# STAFF REPORT COVER SHEET

<b>Addresses:</b>	374-380 Maple Avenue West	<b>Case Number:</b>	PF-58-18-MAC
<b>Public Meeting Date:</b>	3/27/2019	<b>Applicant:</b>	Red Investment LLC and MJW Maple LLC
<b>Board/Commission:</b>	Planning Commission	<b>Owners:</b>	Red Investment LLC
<b>Existing Zoning:</b>	C-1, RS-16	<b>Existing Land Use:</b>	Office
<b>Brief Summary of Applicant Request:</b>	Request for a rezoning to the Maple Avenue Commercial (MAC) zoning district and request for approval of two modifications of requirements for an additional story of parking beyond the allowed 4 stories and a nine foot awning along the Maple Avenue facade. Applicant proposes a mixed-use building (with retail space on the ground floor and multi-family residential condominium units above).		
<b>Site Improvements:</b>	Redevelopment of existing site to include approximately 7,500 square feet of commercial/retail space and 40 multi-family residential condominium units. Improvements also include at-grade structured parking and one level of underground parking.

ITEMS NO. 1 & 2:

Recommendation by the Planning Commission to the Town Council on a proposed rezoning for 380 Maple, a mixed-use building with groun

Figure 3 - Required streetscape along Maple Avenue

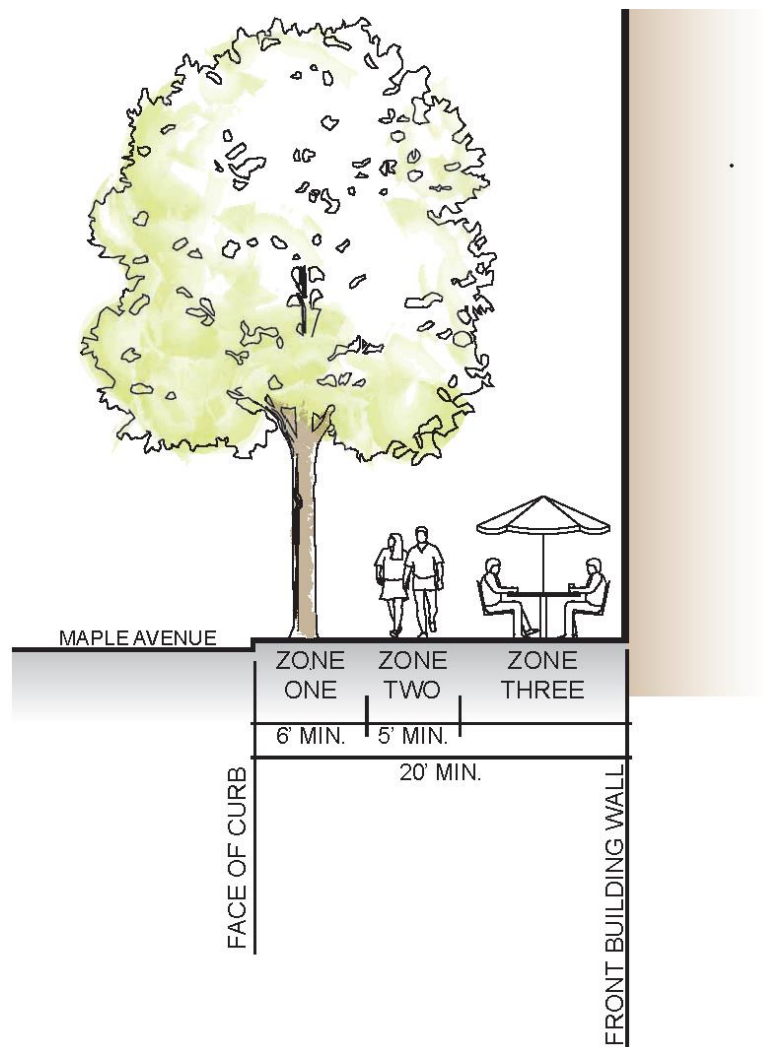
The applicant proposes to continue the standard Maple Avenue streetscape in Zones 1 and 2 that have been implemented along Maple Avenue East and parts of Maple Avenue West. This includes the 6-foot landscape/planter strip and a 5-foot brick sidewalk. For Zone 3, the

Along the majority of Wade Hampton Drive Southwest, the applicant proposes extending the 5-foot sidewalk with a 6-foot wide landscaping strip. Due to the proposed right only turn lane to Maple Avenue, no plantings of a significant height can be planted in the landscaping strip at the corner of Maple Avenue West and Wade Hampton Drive Southwest.

The applicant proposes planting street trees along Maple Avenue West, Glen Avenue Southwest and Wade Hampton Drive Southwest. Due to staff concerns of line of sight along Wade Hampton Drive Southwest, understory trees along the building are proposed in combination with canopy trees.
